Access Compliance Report

Public Rights-of-Way (Curb Ramps)

Intersection ID: 13314	Main Street: BALGREEN_CT	Cross Street: BIEDERBECK_DR	Location:	E
ADA ID: E1CD18062593	Ramp Type: PerpDiag	Initial Pass/Fail: Fail	Overall Compliance: No	Severity Score: 22.5
Codes/Mitigation Info/Possible Solution		Field Measurements/Component Compliance

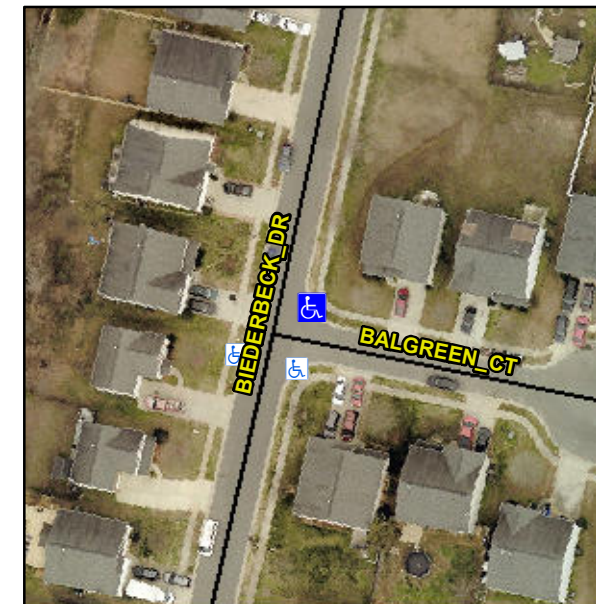
Not Found, R304.5.1, R304.2.2, R304.5.3

Compliance	Description	Data	Compliance	Description	Data
N/A	Ramp Length (in)	48.0	No	Ramp Slope (%)	10.2
No	Ramp Width (in)	40.0	No	Ramp XSlope (%)	4.0
N/A	Flare Type LT	N/A	N/A	Flare Type RT	N/A
N/A	Flare Slope LT (%)	N/A	N/A	Flare Slope RT (%)	N/A
N/A	Flare Traversable LT?	N/A	N/A	Flare Traversable RT?	N/A
N/A	Landing Length (in)	N/A	N/A	DWS Provided?	N/A
N/A	Landing Width (in)	N/A	N/A	DWS Contrast?	N/A
N/A	Landing Slope (%)	N/A	N/A	DWS Length (in)	N/A
N/A	Landing X Slope (%)	N/A	N/A	DWS Full Width?	N/A
N/A	Landing Curb? (Y/N)	N/A	N/A	DWS Offset (in)	N/A
N/A	Shared Landing?	N/A			
N/A	Gutter Ponding?	N/A	N/A	Gutter Slope (%)	N/A
N/A	Gutter Lip Ht (in)	N/A	N/A	Gutter X Slope (%)	N/A
N/A	Painted X Walk1?	No	N/A	Painted X Walk2?	No
	X Walk 1 Direction	To NW		X Walk 2 Direction	To SW
N/A	X Walk 1 Width (in)	N/A	N/A	X Walk 2 Width (in)	N/A
	X Walk 1 Slope (%)	5.2		X Walk 2 Slope (%)	0.5
	X Walk 1 X Slope (%)	1.3		X Walk 2 X Slope (%)	1.2

N/A	Ramp inside XWalk1?	N/A	N/A	Ramp inside XWalk2?	N/A
	Road Slope (%)	1.8	N/A	Clear Space?	N/A
	Road X Slope (%)	4.8	N/A	Clear Space to XWalk (in)	N/A
N/A	Any Obstructions?	N/A	N/A	Storm Grate/Utility Hazard?	N/A
	Obstruction Type			Storm Grate/Utility Type	
		N/A			N/A
			Yes	Surface Condition? (G/P)	Good

Remove & Replace Curb Ramp With Two New Directional Ramps or Equivalent.
